# APPELLANT'S SUBMISSIONS

# NOTICE OF REVIEW

18/0433/PP - Erection of 4 detached Dwellinghouses, formation of access road and associated parking at land to east of Brown Street, Stoney Brae, Paisley.

**TABLE 1 – 24.07.2019 / Requirements from Roads Planning Officer**

Title  
Highways Layout &  
Cross Sections

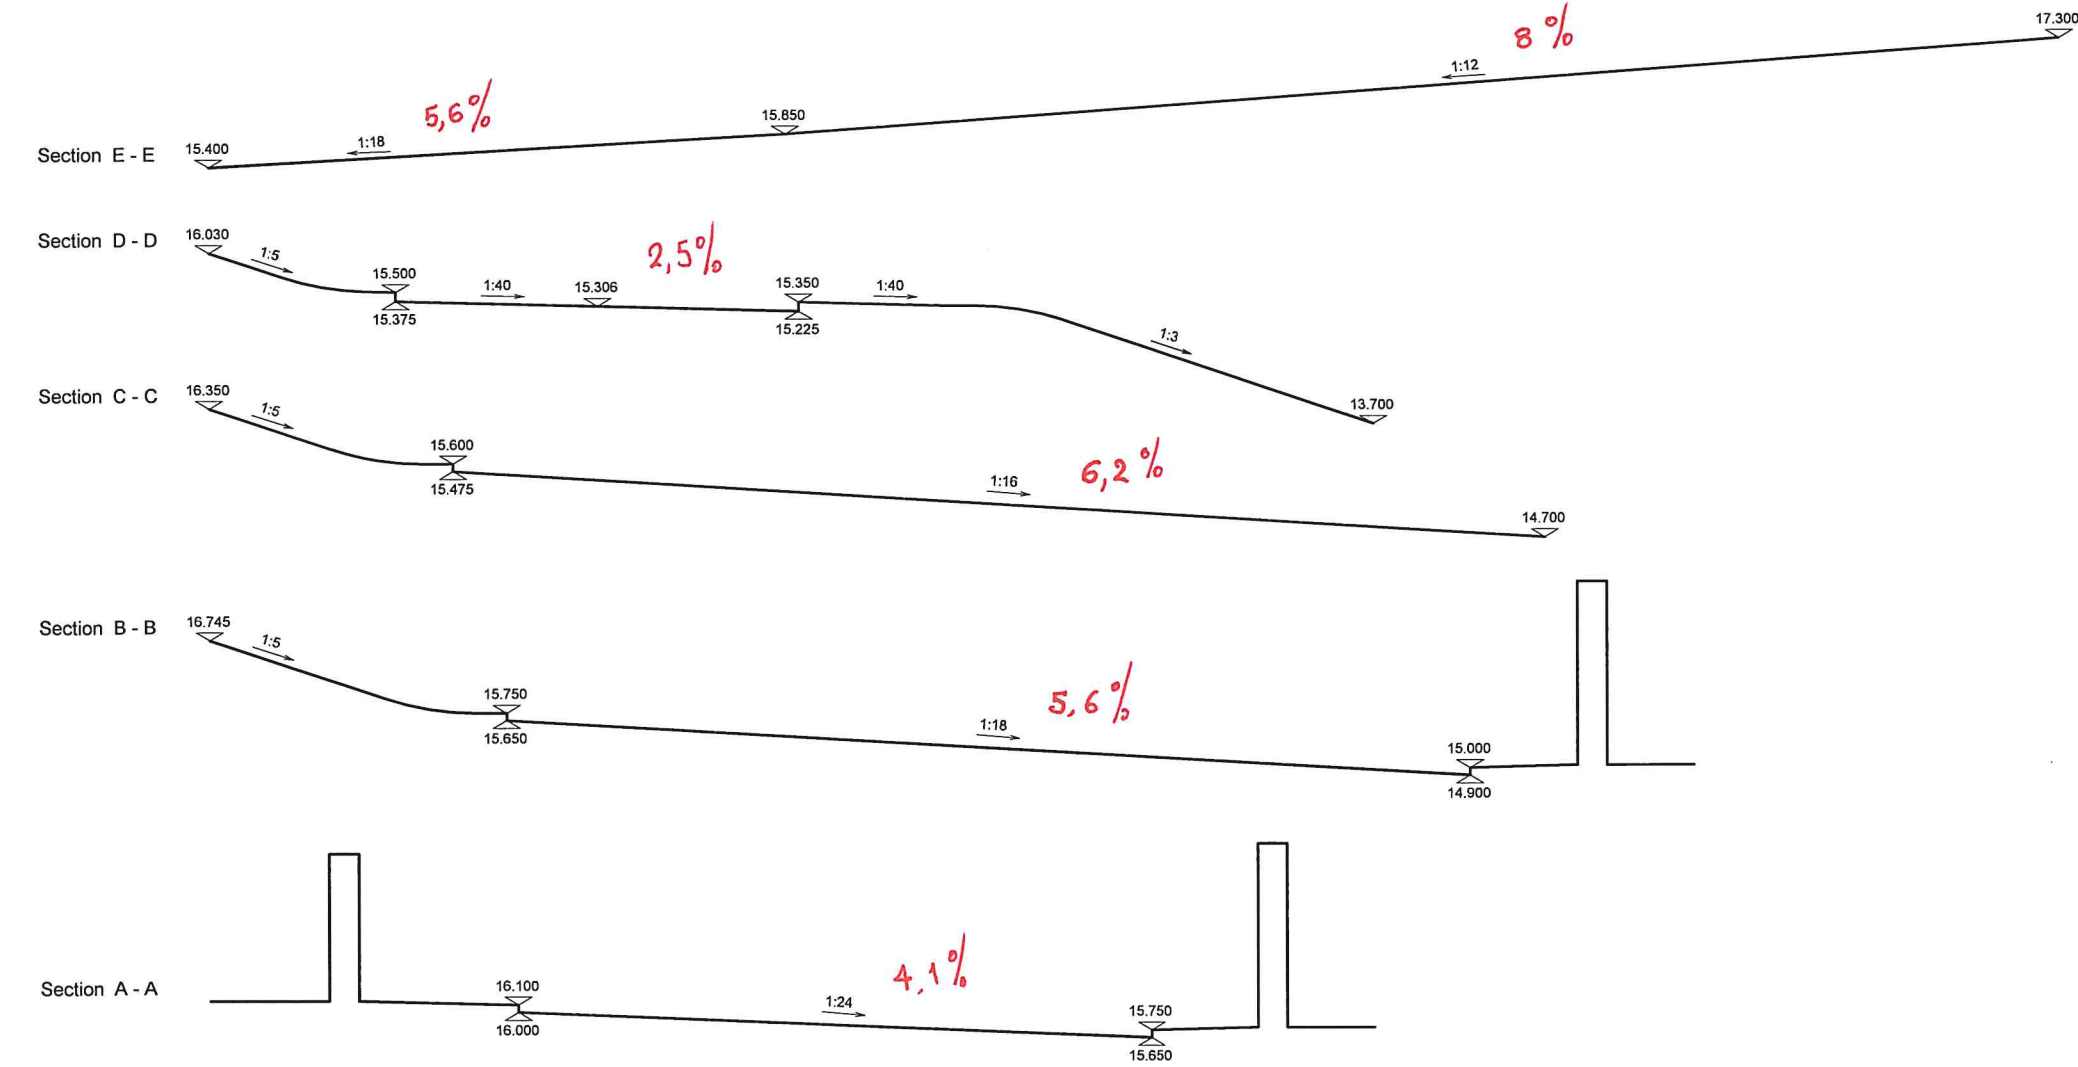
Initial Comments issued by Roads Planning Officer per email 24th June 2019	Response by Owner/ Developer Submitted 24 <sup>th</sup> July 2019	Roads Department Response received 21-9-19
<p>1. "... Before I can proceed, I need vertical alignment information including an assessment to demonstrate that a high sided vehicle such as a bin lorry will not tip over when making the maneuver..."</p>	<p>1. To demonstrate that high sided vehicles such as a bin lorry <b>will not tip</b> over when making the maneuver, we are providing here our <b>revised Drawing A4187 No.2 Revision A</b>, with <u>Swept Path Analysis</u>, and including <u>5 additional Sections</u>, taken at the entrance junction with Hunter St, which demonstrate the following:</p> <p>1.1. <b>the new proposed junction allows the Bin Lorries to enter directly into the Old Graveyard from Hunter St., which means that the Bin Lorry will not need to descend down Stoney Brae and will not need to turn 90 degrees left, but instead will enter directly into the site entrance opposite Hunter St., therefore high sided Bin Lorries will not tip over when making the maneuver.</b></p> <p>1.2. <u>All centerlines follow in parallel with natural contour lines and thus achieve less than 8% or (1:12) gradient, shown with Longitudinal Section E-E', along centerline at junction with Hunter St. The gradients range from 5% to 6.2% max, not exceeding 8% or (1:12) in compliance with National Road guidelines.</u></p> <p>1.3. At the proposed junction with Hunter St., the cross-fall gradients along <u>Sections A-A', B-B' and C-C'</u> in likewise range from 4% to 6.2% max, and do not exceed at any point that of 8 %, in line with National Road guidelines.</p> <p>1.4. At the entrance point to the old Graveyard, the Crossfall of the internal road smoothens out to 2.5% or (1:40) with <u>Section D-</u></p>	<p>No sections are shown on Drawing A4187 No.2 Rev. A</p> <p>The is insufficient information on the drawing to demonstrate or prove this</p> <p>There is no level information on the drawings only contour lines which re inaccurate as they continue over retaining walls with no change in level shown whilst there is obvious change in levels on site – Until detailed levels are shown no further comment can be made</p> <p>No sections are shown- perhaps these are on another drawing</p>

<p>5. "... And demonstration that the design can be in</p>	<p>5.1. The Road Layout drawings has been shown in accordance with Designing Streets National Guidelines i.e. 5.5m wide, with 6.0m radius entrance, including gradients and cross-sections including Gradients as already detailed in paragraph No. 1</p>	<p>Before further comment can be given long sections of the centerline of the road and wheel lines of a vehicle travelling from Hunter st to the new development are</p>

<p>accordance with designing streets and the national guidelines - not that it will be which isn't satisfactory for planning purposes in this case as it is unlikely it can be achieved..."</p>	<p>above. The Layout drawing however as per our obligation does <u>not</u> constitute full details that would be required for a <u>Section 21</u> agreement, which will be required eventually. It is hence noted <u>Section 21</u> details do not have to be provided until after Planning Consent is granted and not warranted at this present stage.</p> <p><b>5.2.</b> We have effectively relocated the main access entrance per the Council's recommendation to pass directly inside the old graveyard so as to secure safe gradients for all types of vehicles (with less than 8% gradient in longitudinal direction and 1:16 to 1:40 in the lateral direction) as depicted in our revised Drawing <u>A4187 No.2 Rev. A.</u> It is noted that final road profile, with detailed cross-sections and gradients are subject to detailed design development to receive final approval at the Planning Permit stage, which will also be duly submitted as "<u>Roads Construction Consent Application</u>" as requested per Item. No3. Listed in Table 4 (Pre-Condition for previously approved Planning Permission 10/0701/pp, issued in 2011).</p> <p>5.3. The detailed information submitted so far is sufficient to demonstrate the road layout is correct and workable and feasible to be constructed to the required Authority standards and regulations, subject to further detailed design and shop drawing development that normally is commissioned <u>after</u> receiving the Council's Planning consent.</p>	<p>required and will need to demonstrate there is not a risk of overturning or grounding</p> <p>The council have not recommended the routing of this road within the graveyard rather have suggested it is likely the only option if access is to be taken to the proposed development plots. The acceptability of this proposal is not presently under consideration. Only if it is possible in engineering terms is being considered</p> <p>It is not unusual that nearly all the roads design is required at planning stage, especially when it is considered very difficult or complicated to do.</p> <p>There is currently insufficient roads detail for a recommendation to proceed to be given</p>

<p><u>D'</u> and continues internally along natural Contour lines, and complies with National Road guidelines</p> <p>1.5. We believe that these 5 Section drawings suffice as assessment to prove that the access is safe for the Bin Lorries and Fire Appliances, since</p> <p>1.6. However, if so required can provide additionally a <u>Static Calculation Report</u> to demonstrate that the center of gravity of high sided Bin Lorry will never reach tipping level, regardless of maximum load conditions.</p> <p>1.7. As a contingency we are prepared to consider the alternative option to create a collection area directly at the entrance point, with suitable maneuvering space (i.e. Muster point) and to have the residents collect all their rubbish and refuse there. In this case the Bin Lorries will exit without entering further into our property, thus avoiding any hypothetical risk.</p> <p>1.8. Additionally, we are willing to provide a Legal Undertaking letter to this effect, confirming our proposed access road is perfectly safe for all types of vehicles, including large sided vehicles, to fully cover intended liabilities.</p> <p>1.9. We consider that further engineering assessment other than the above, is not warranted at this present phase, bearing in mind, that <u>Section 21</u> details do not have to be provided until after Planning Consent is granted. Further details will be submitted as a "Roads Construction Consent Application" as is requested per Item. No3 of Pre-Conditions for Planning Permission 10/0701/pp, issued 2011</p>	<p>Details of the limitations of the crossfall that service vehicles can traverse are needed. These should be demonstrated not to be being exceeded. No such information is available</p> <p>Fire trucks still need access and bins need to be within 25m of the premises</p> <p>No Need- quite happy to have it demonstrated on paper</p>

Title  
Highways Layout, Visibility Splays &  
Swept Path Analysis

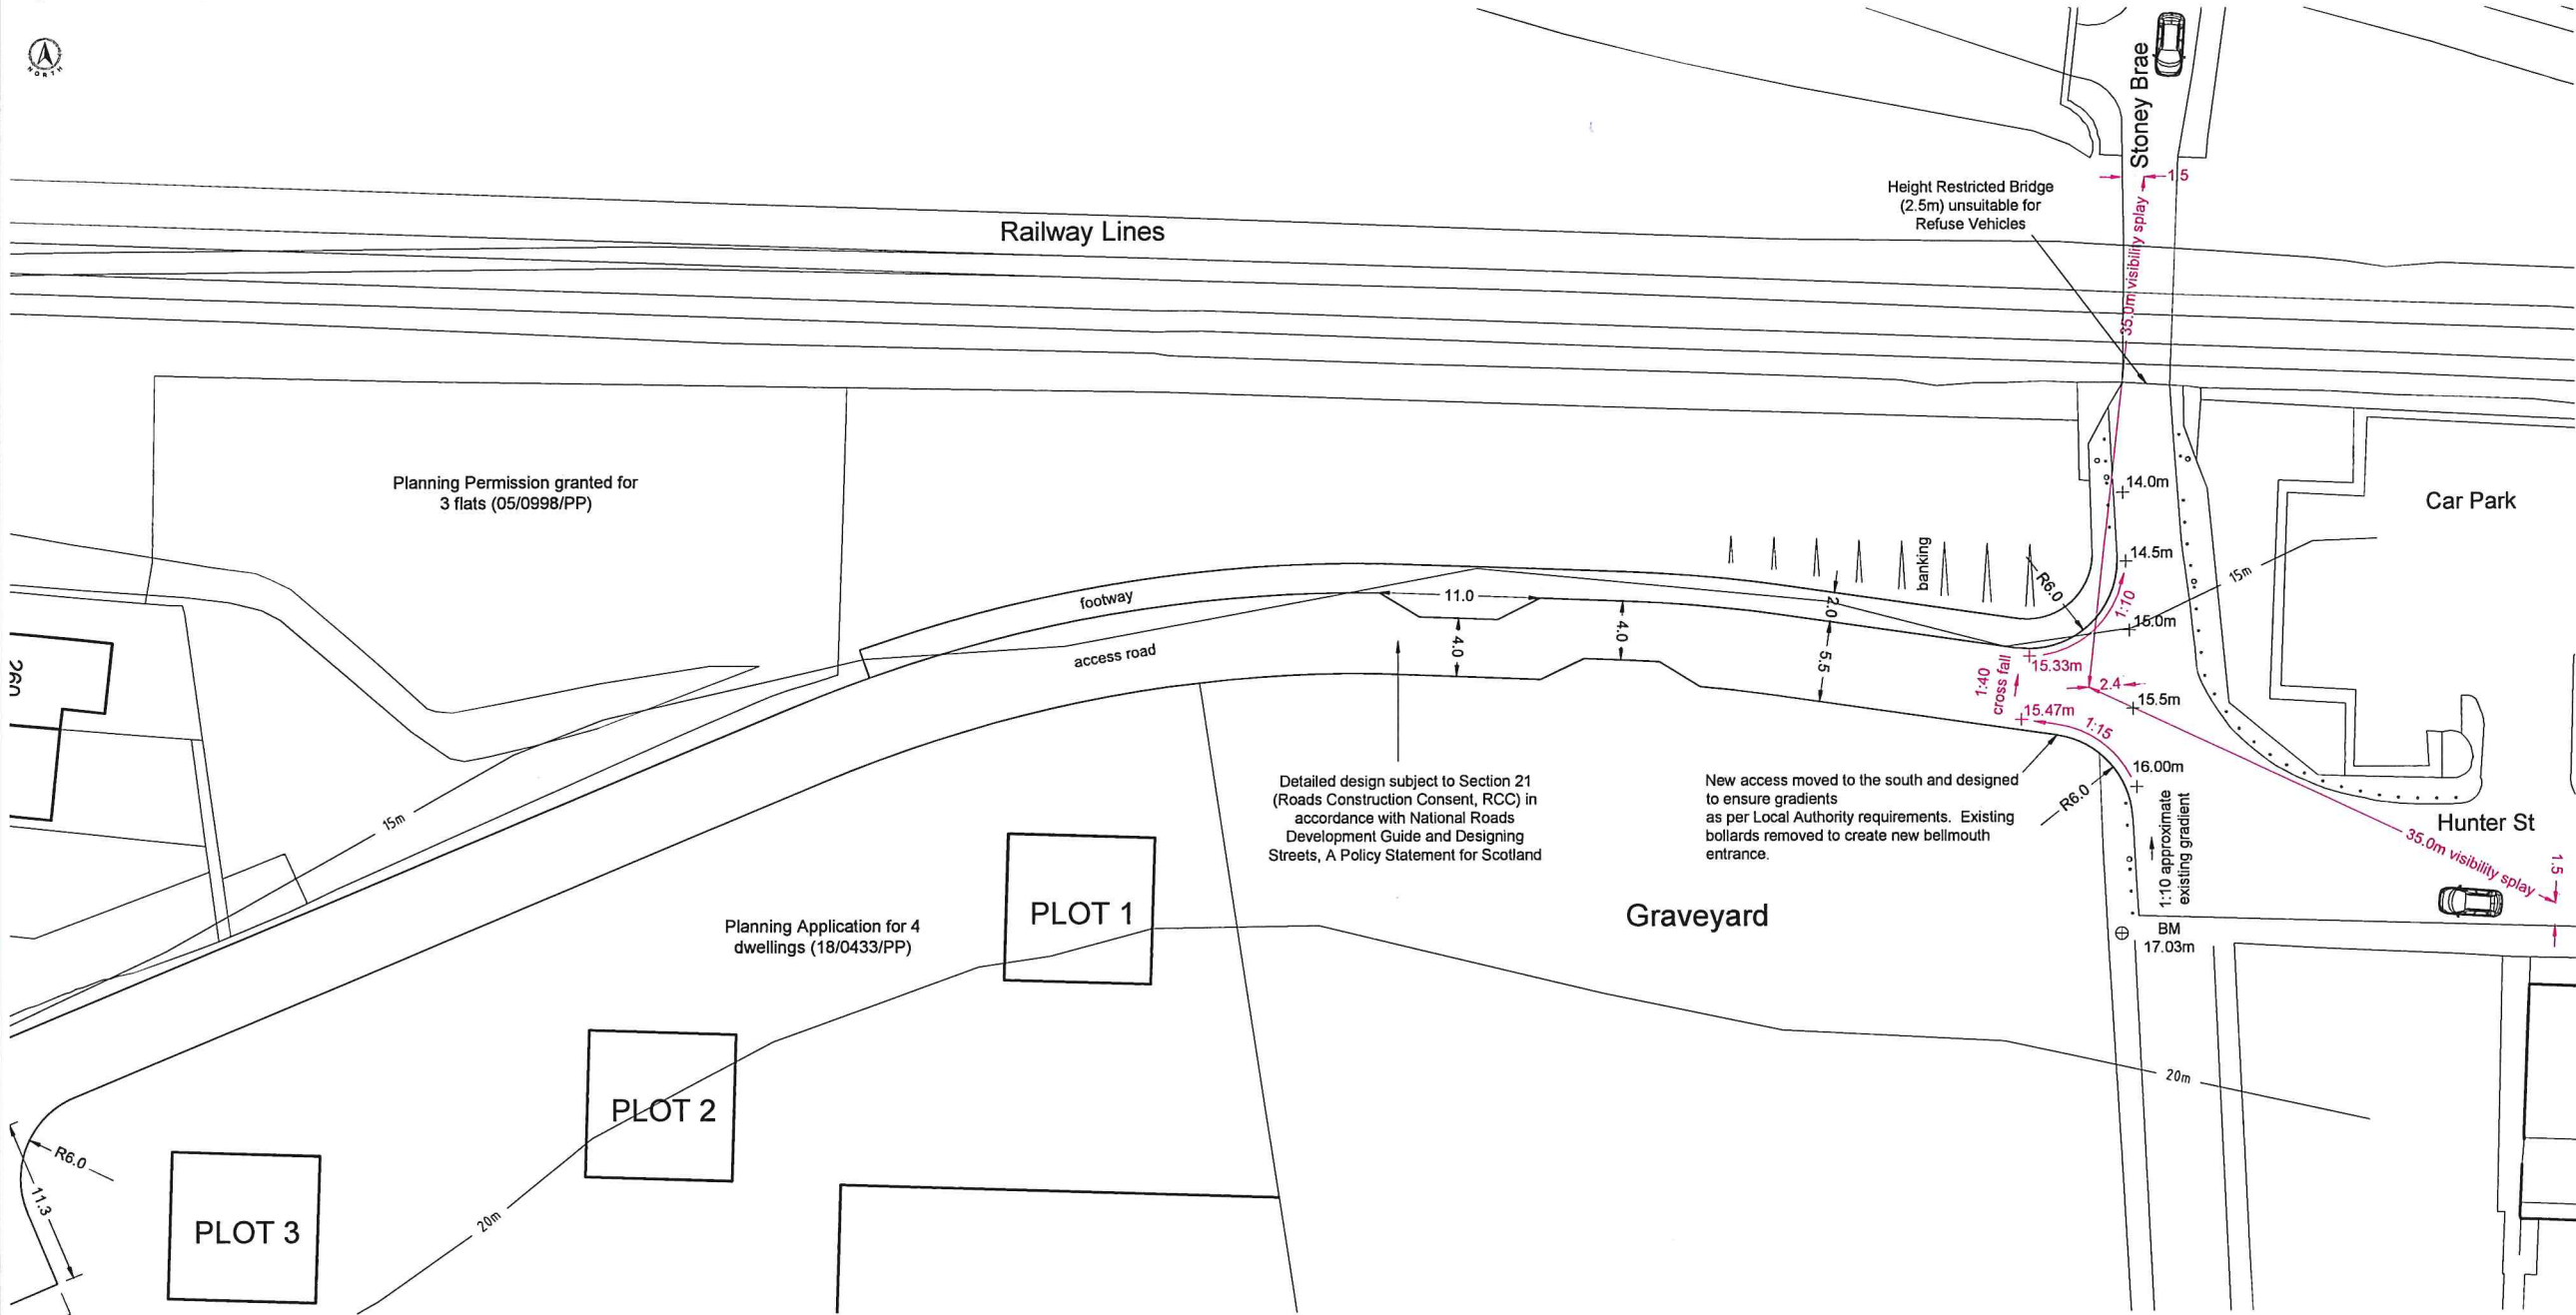
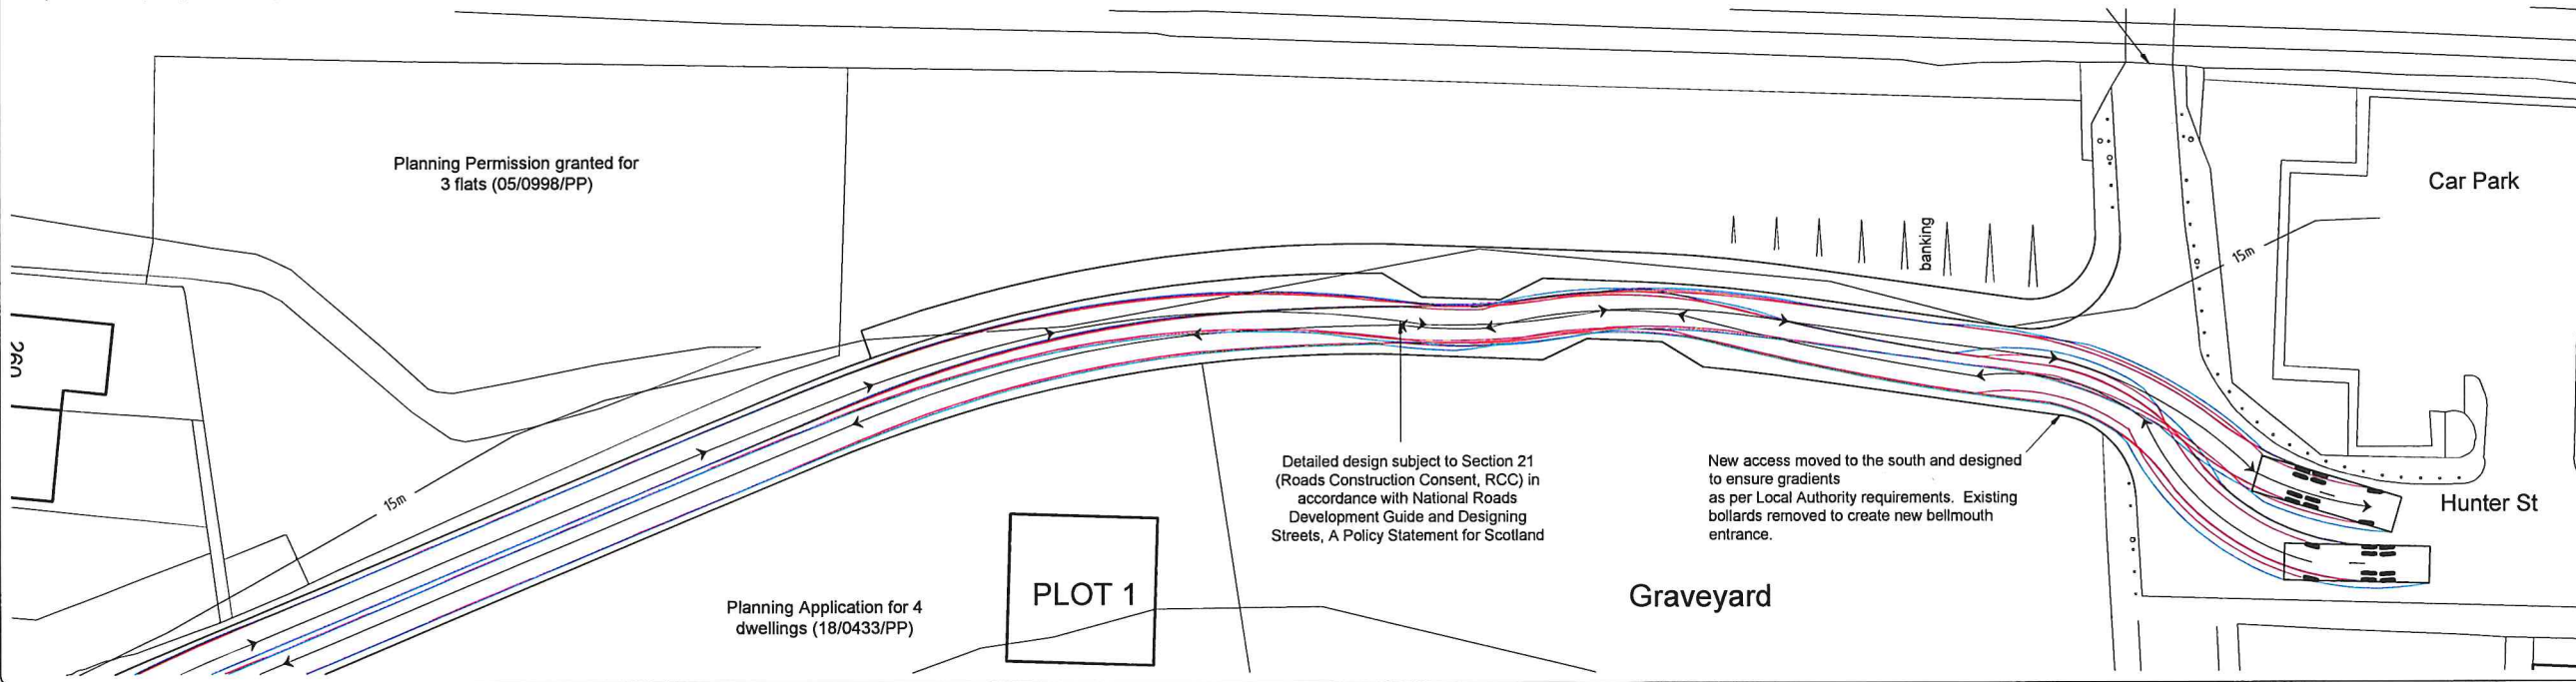
<p>2. “... Before though considering vehicles, we need to consider pedestrians and I would also need to see a footway being proposed on the south side of the new junction ...”</p>	<p>Separate 2m Footways are provided either side along the full length of the access entrance road, both to the North and to the South, as depicted on our revised <u>Drawing A4187 No.2 Rev. A</u>, here attached</p>	<p>Drawing A4187 No.2 Rev. A shows a discontinuous footway only on the north side terminating at plot1</p>
<p>3. “... I additionally reiterate that confirmation of the 35m forward sightline comes from would be nice...”</p>	<p><b><u>This Visibility Requirement was requested per email received 22<sup>nd</sup> January 2019, as a pre-requisite for at least 20m clear sightline – see stated below Table 4 item No10, as Pre-Condition for previously approved Planning Permission 10/0701/pp, (2011):</u></b></p> <p><i>“... A minimum forward visibility sightline of 20m will be required. (reduced from 35m on account of the area being traffic calmed...”</i></p> <p>3.1. Since our present development plan is an exact reproduction of this initially approved Permit 10/0701 (with improvement to the entrance road access), therefore this visibility condition was carried over as a standing requirement.</p> <p>3.2. To justify in lay-terms a 35-meter clear line of visibility is considered a safe warning distance for vehicles travelling at 28mph. Moreover, in this location, from a practical point of view, vehicles are not able to travel at a speed of 28 mph, since this is a historical area with cobble paved avenues, and not a main traffic route. Since speed limit is restricted, hence 35-meter visibility line is considered sufficient for vehicles exiting the site access.</p>	<p>35m forward visibility is noted in drg Drawing A4187 No.1 Rev. A- no further comment</p>

3. The junction design onto Hunter st needs further developed and resubmitted. The design needs to include horizontal and vertical designs and swept paths of a 3-axel bin lorry conforming to the council's specification.	COMPLIED - PROVIDED WITH OUR DRAWINGS (A4187-No.1, and No.2 – see here attached)

4. The developer should note that swept paths entering and exiting the site for a fire appliance will also be required	COMPLIED - PROVIDED WITH OUR DRAWINGS (A4187-No.1, and No.2 – see here attached)	
5. Confirmation if the road is to be adopted will be needed (it's too long in an urban setting to be a private access so the bin lorry needs to be able to go in to the last house)	CONFIRMED

4. min sightlines of 2.5x35x1.05m are required,	COMPLIED – PROVIDED <b>SEE DRAWING TITLED VISIBILITY SPLAY ATTACHED</b>	
5. Water shall be trapped and contained within the site so as not to drain onto the public road	AGREED – ACKNOWLEDGED to be provided

10. A minimum forward visibility sightline of 20m will be required. (reduced from 35m on account of the area being traffic calmed)	COMPLIED – PROVIDED SEE DRAWING TITLED VISIBILITY SPLAY ATTACHED

<p>3.3. As demonstrated in our Drawing (A4187-No.1, attached) a clear line of vision is feasible well beyond that of 35-meters towards the east with Hunter St. which is the main access route. Likewise, a 35-meter line of vision is clear for private vehicles exiting to the north passing under the Railway bridge.</p> <p>3.4. We need to highlight that the Council's Bin Lorries will never exit to the north to the Railway bridge since this bridge has a height restriction of 2.5 m and therefore cannot be accessed by heavy trucks or high lorries, and this should weigh accordingly, when considering visibility requirements.</p>	
<p>4. "... In respect of sightlines please note the standard that a distance of 1.5m off the herb should be measured to. This I see isn't being achieved on your drawing because of the adjacent wall to the left nor to the right because of the retaining wall of the car park opposite..."</p>	<p>We also need to highlight that the visibility restrictions mentioned due adjacent walls have been removed per our revised Drawing <u>A4187 No.2 Rev. A</u>, and Drawing titled <u>VISIBILITY SPLAY</u>, since the main access is shifted to the south, and passing directly inside the old Graveyard, with clear visibility directly in front of Hunter St.</p> <p>Additionally, the old gate is removed and the bell-mouth is adjusted accordingly with entrance <u>5.5m wide and 6.0m radius entrance</u> and therefore all obstacles to sightlines have been removed allowing clear visibility for vehicles approaching the existing into the site, therefore the visibility and sightlines issues are now successfully resolved.</p>
